Concerns regarding the Devil's Gate Sediment Removal Project

La Canada Flintridge Parents for Healthy Air

November 1, 2018

Proposed Hauling Schedule and Routes

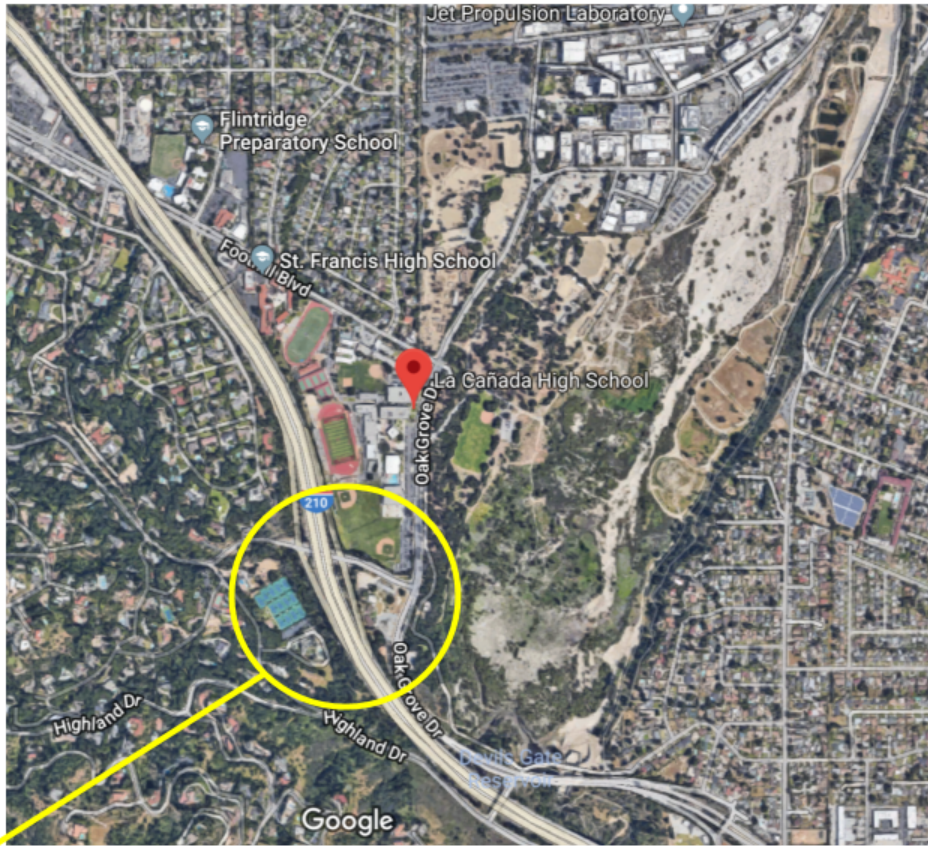
- 4. The Traffic Impact Analysis (TIA) for the Oak Grove/Berkshire Place/210 ramps segment of the Project's hauling route is incomplete and outdated; the absence of any real analysis jeopardizes the public safety of this highly trafficked intersection.**

- a. The hauling route relies heavily on Oak Grove for vehicle entry and exit during the Project's removal phase. The diesel dump trucks using this route will idle significantly longer than anticipated, due to the amount of cars departing JPL and La Canada High School at various times of the day. This causes significantly more pollution for the Project's overall daily maximum of NOx.

- b. The presence of a 4-way stop sign at the off- and on-ramps of the 210 on Berkshire Place means that exiting trucks will spend more time at low speed and idling before entering the 210 westbound on-ramp. At 50 trucks per hour, the NOx from trucks idling to turn onto the freeway will be significant.

- c. The magnitude of parent, student and employee traffic along the traffic route between 3:00 and 5:30 PM is not documented, and this omission will make it difficult for trucks to enter the freeway and for people to get home.

Parents' Request #4: Obtain a new Traffic Impact Analysis that addresses the flow of entering and exiting trucks, especially along the segment of Oak Grove/Berkshire Place/210 ramps. The amount of idling (increased NOx output), the conflict with existing traffic at this location due to JPL, LCHS plus 2 other schools, and the need for synchronized turn lanes to accommodate the volume of trucks -- these important issues all point to the need for a new traffic analysis. The existing infrastructure poses severe hazard to those traveling in the area during the hauling season.
